Access Compliance Report Public Rights-of-Way (Curb Ramps)

Intersection ID: 20806	Main Street: OLD_REID_RD	Cross Street: PATRICK PL	Location: W
ADA ID: 9E6394FB1C81	Ramp Type: PerpDiag	Initial Pass/Fail: Fail	Overall Compliance: No Severity Score: 12.5

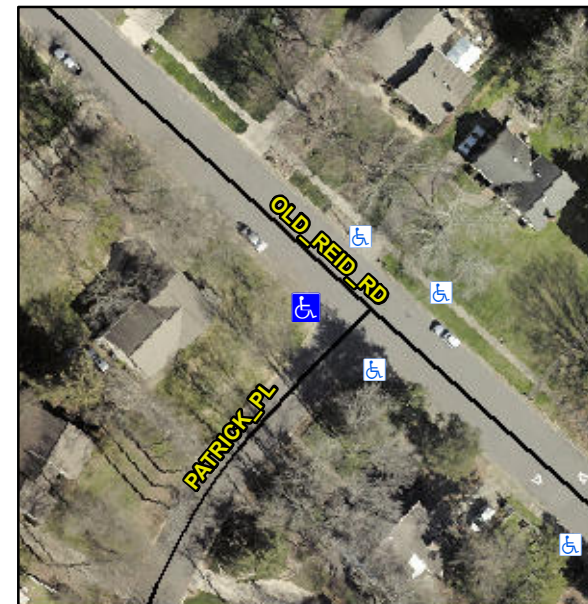
Not Found, R304.2.2

Compliance	Description	Data	Compliance	Description	Data
N/A	Ramp Length (in)	50.0	No	Ramp Slope (%)	9.0
Yes	Ramp Width (in)	57.0	Yes	Ramp XSlope (%)	1.8
N/A	Flare Type LT	N/A	N/A	Flare Type RT	N/A
N/A	Flare Slope LT (%)	N/A	N/A	Flare Slope RT (%)	N/A
N/A	Flare Traversable LT?	N/A	N/A	Flare Traversable RT?	N/A
N/A	Landing Length (in)	N/A	N/A	DWS Provided?	N/A
N/A	Landing Width (in)	N/A	N/A	DWS Contrast?	N/A
N/A	Landing Slope (%)	N/A	N/A	DWS Length (in)	N/A
N/A	Landing X Slope (%)	N/A	N/A	DWS Full Width?	N/A
N/A	Landing Curb? (Y/N)	N/A	N/A	DWS Offset (in)	N/A
N/A	Shared Landing?	N/A			
N/A	Gutter Ponding?	N/A	N/A	Gutter Slope (%)	N/A
N/A	Gutter Lip Ht (in)	N/A	N/A	Gutter X Slope (%)	N/A
N/A	Painted X Walk1?	No	N/A	Painted X Walk2?	No
	X Walk 1 Direction	To SW		X Walk 2 Direction	To NE
N/A	X Walk 1 Width (in)	N/A	N/A	X Walk 2 Width (in)	N/A
	X Walk 1 Slope (%)	0.8		X Walk 2 Slope (%)	3.0
	X Walk 1 X Slope (%)	0.1		X Walk 2 X Slope (%)	0.1

Remove & Replace Curb Ramp With Two New Directional Ramps or Equivalent.
